Delegated Report

Householder Planning Application

Planning Application No: 20260121

Description: Erection of a single storey rear extension with two roof lanterns. Alterations with extensions to either side of the roof to form a jerkinhead roof. Loft conversion into habitable rooms with one dormer window to front and roof lights and one to rear elevations. Erection of front porch. Excavation of rear garden to create entrance to rear extension.

Proposed Elevations (Not to Scale)

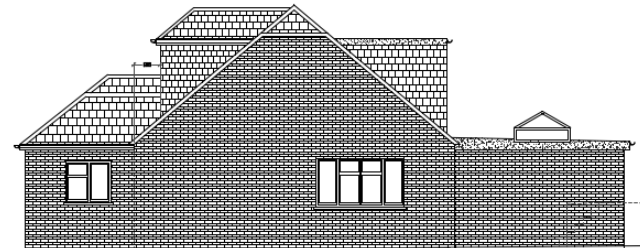
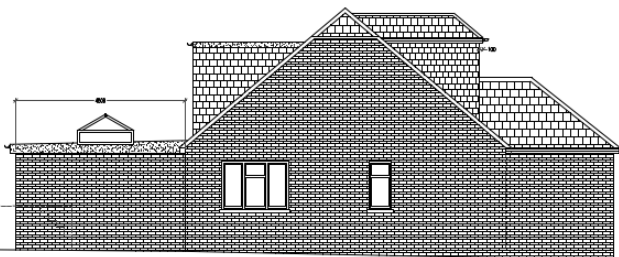
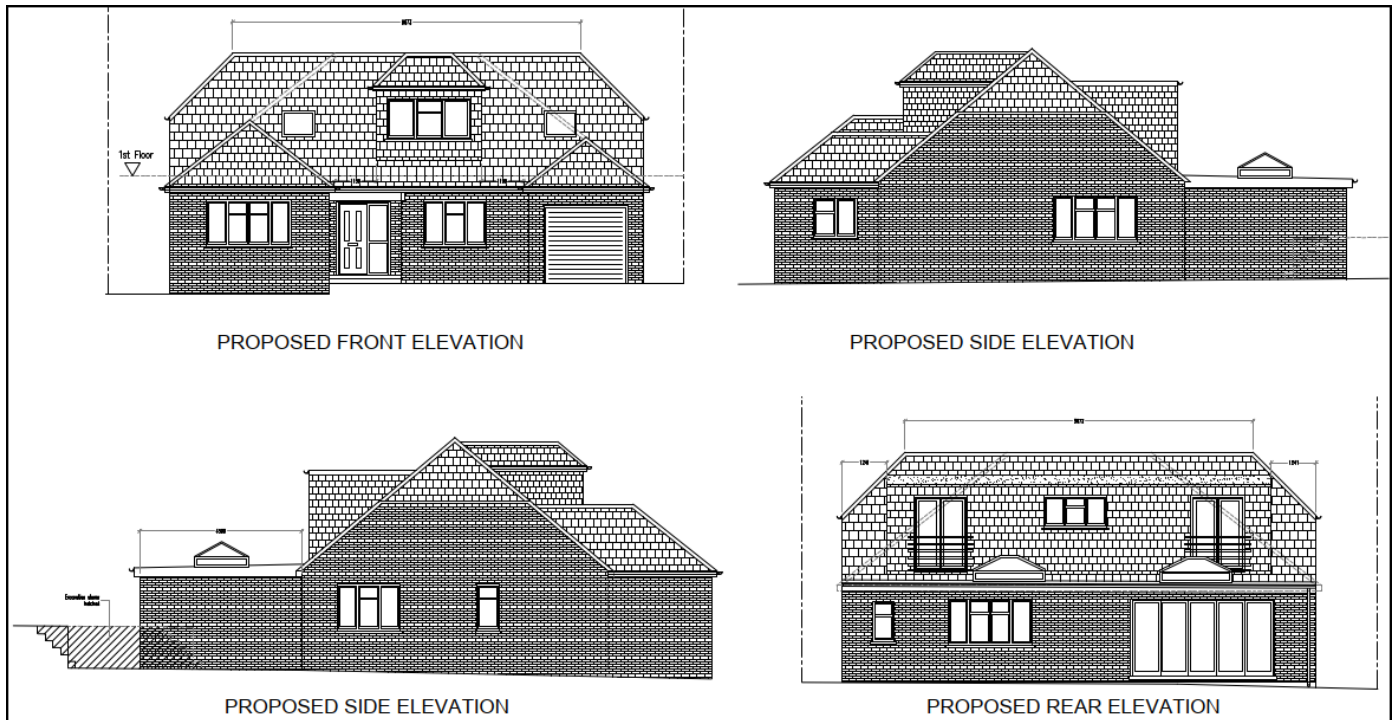
The changes proposed are as follows:

- One dormer proposed to front elevation, instead of 3
- 2no. rooflights now proposed to front elevation
- Altered roof form with more distinctive and enlarged hip ends to the sides
- Reduced width to rear dormer

On the previous application it was concluded that the roof additions both separately and cumulatively would be an incongruent, form of development with inappropriate features, which would result in excessive bulk, disbalancing of the appearance of the upper and lower floors, create a cluttered roof form and interrupt the pattern of roof forms within the streetscene. It was advised that for such a development to be made acceptable significant reductions in both the internal layout, external roof bulk proposed and altered design approach would be necessary. In this new application whilst there have been some tokenistic reductions in scale and marginal improvement in design aesthetic, when viewed as a total development, the original conclusions that the development would be incongruent with the character of the area, and representative of overdeveloped scale, remain. The reason for refusal on the previous application has therefore not been

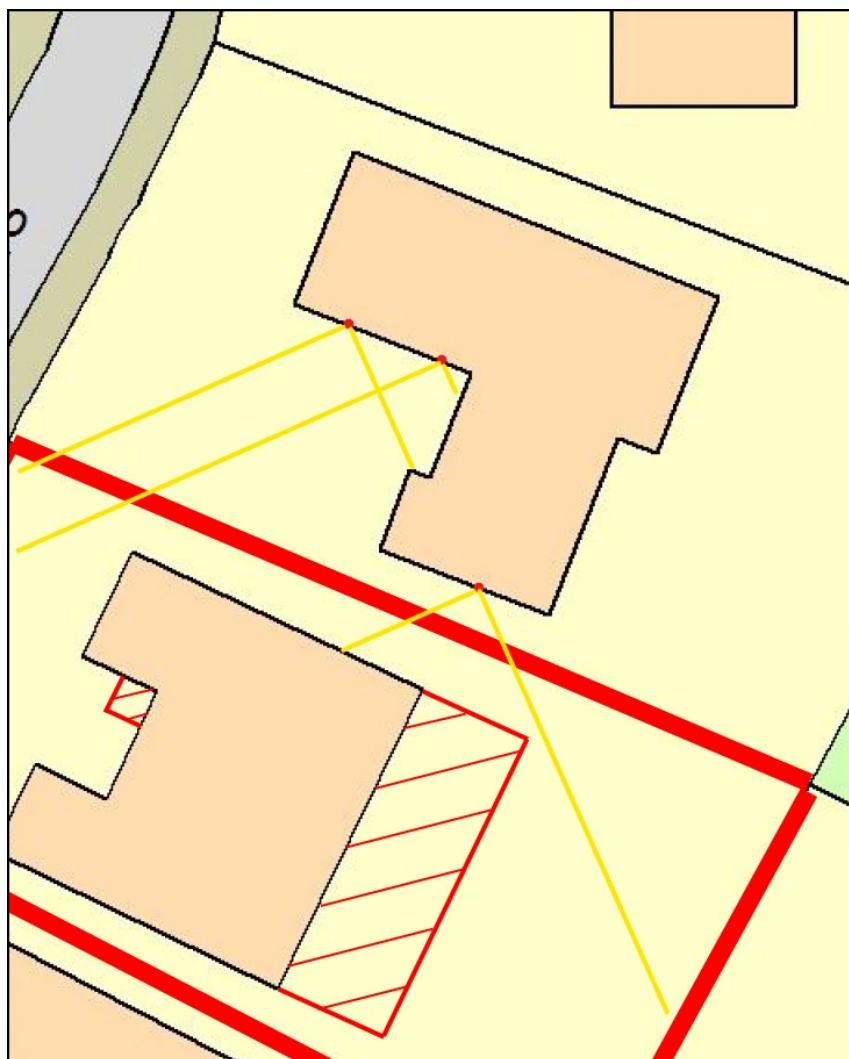
In 2017 a Lawful Development Certificate was granted for 3 The Yews for a rear dormer and extension under planning reference 20170312. This appears to have been completed. The floor plans for that proposed scheme shows the window layout. As shown below there are windows facing the subject property which consists of a garage, entrance hall and bedroom.

Based on the below 45 degree test, the only window potential overshadowed by the subject dwellinghouse is the garage. As this is a non-habitable opening, the overshadowing would not be considered significantly harmful to the residential amenity of this neighbouring property.

45 degree test

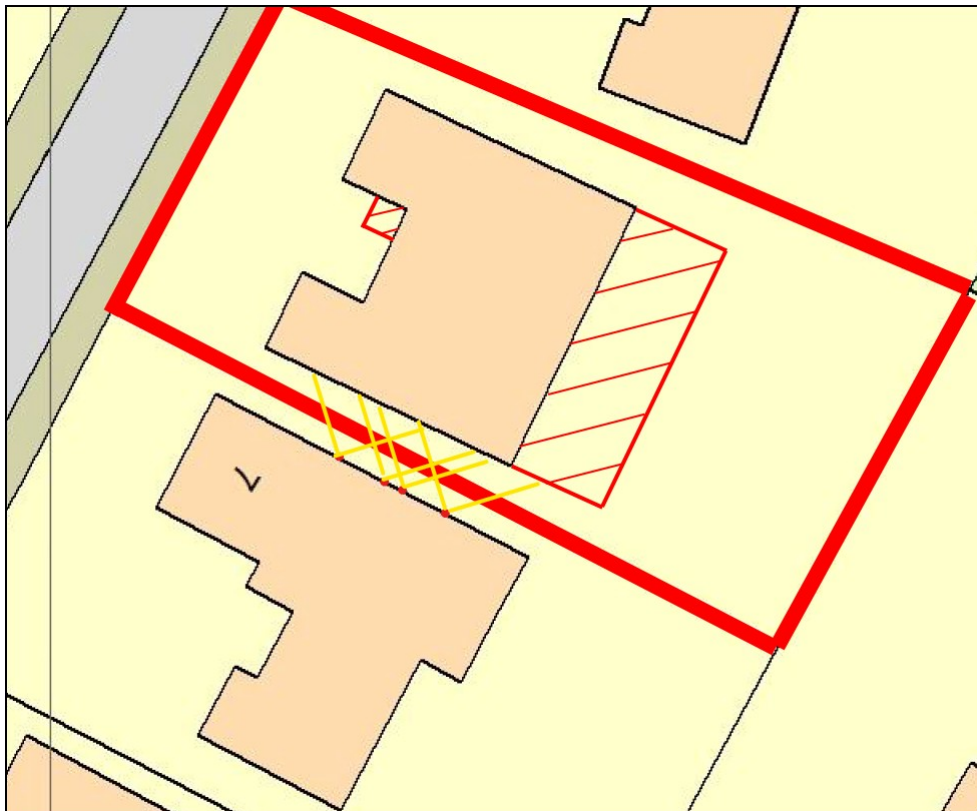
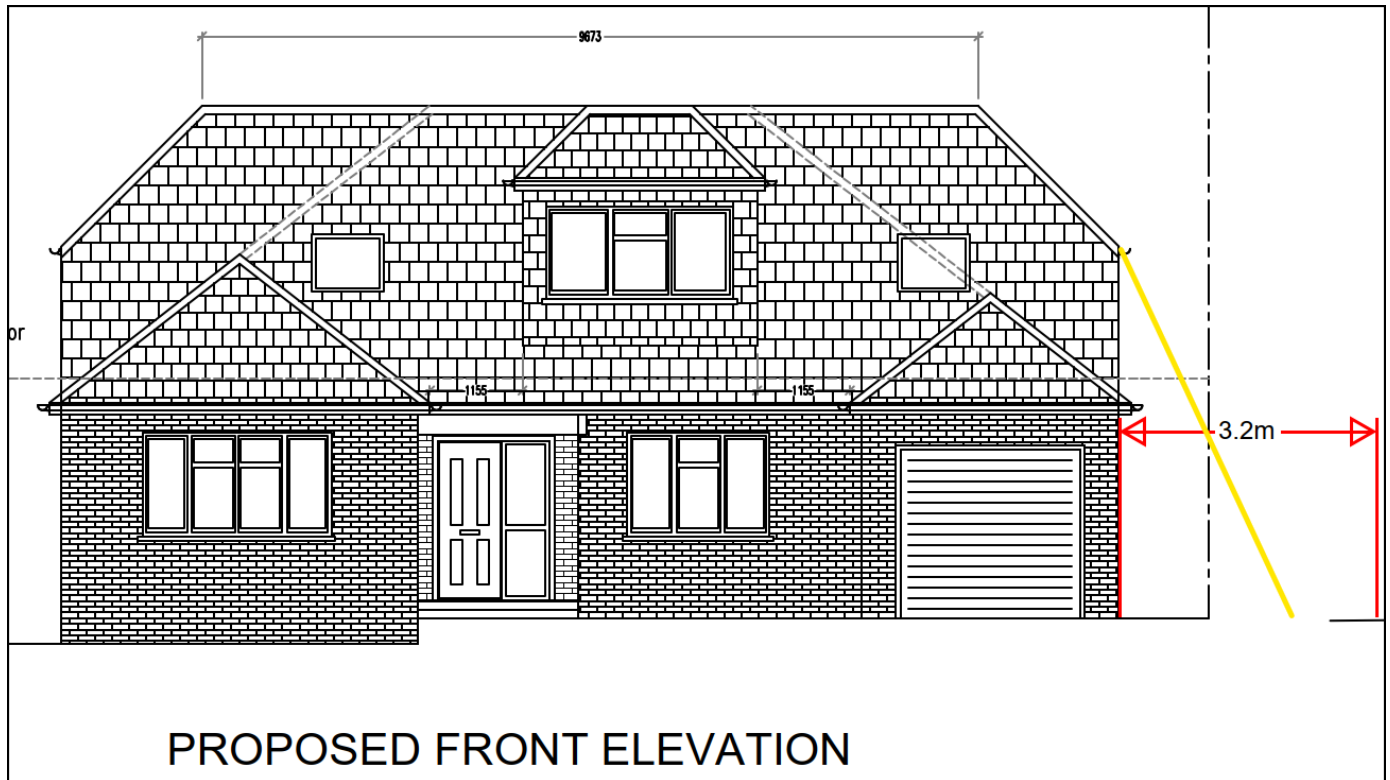
The below 45 degree test shows that based on the window position and relationship between the buildings there is potential for overshadowing.

Further 25 degree elevation tests are therefore required as below. It is noted this neighbour is on a slightly elevated position and so this has been factors in the approximate window position which is indicated by the red dot.

As can be seen due to the distance between the properties, the 25 degree test shows that there would not likely be any overshadowing of this neighbours openings. In terms of overlooking, the proposed development would not alter the arrangement of openings to the side elevation and so there would be no exacerbated overlooking as a result of the proposed development. There is a flat roof to the rear which would be adjacent to Juliet balconies. A condition would be applied ensuring the flat roof could not be used as a balcony should the development be approved.

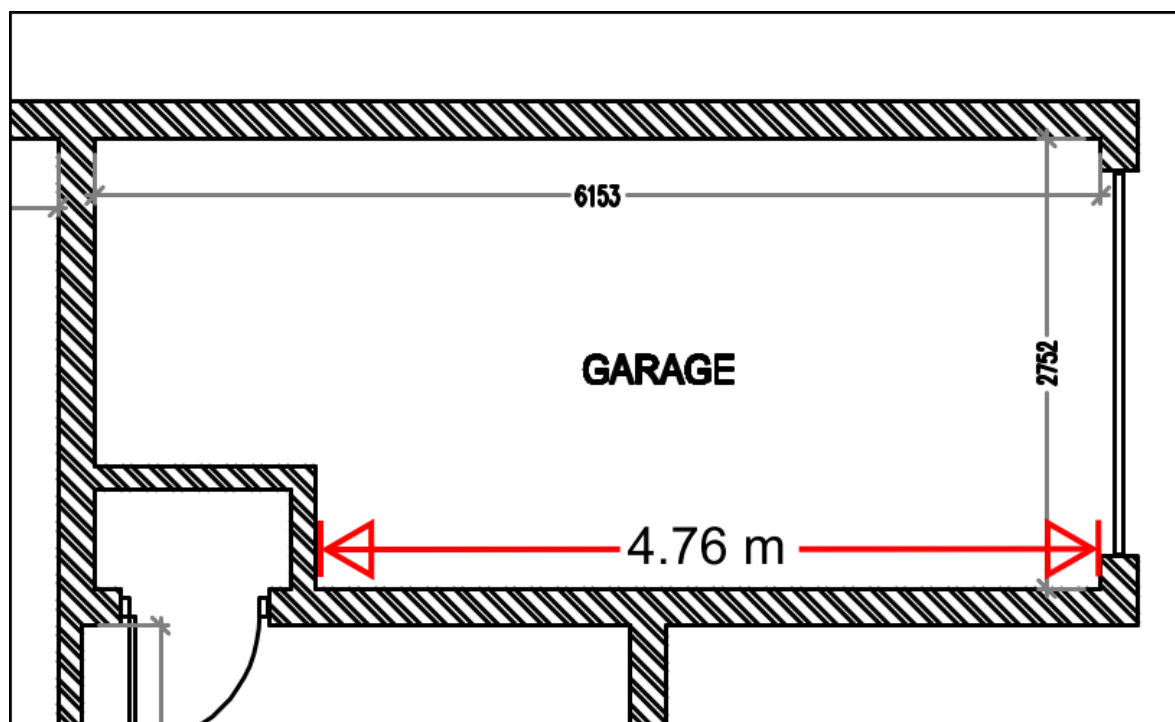
The garage falls short of the required spacing for a garage as shown in the below image:

Adequate vehicle parking provision can be achieved with some further works to the garden, and any future submission should ensure that three spaces are provided, in order to accord with paragraphs 109 to 114 of the National Planning Policy Framework (2024), Saved Policies T1 and P3 of the Local Plan First Review (1994) and Policies CS11 and CS19 of the Core Strategy 2014 subject to further details of cycle parking provision.
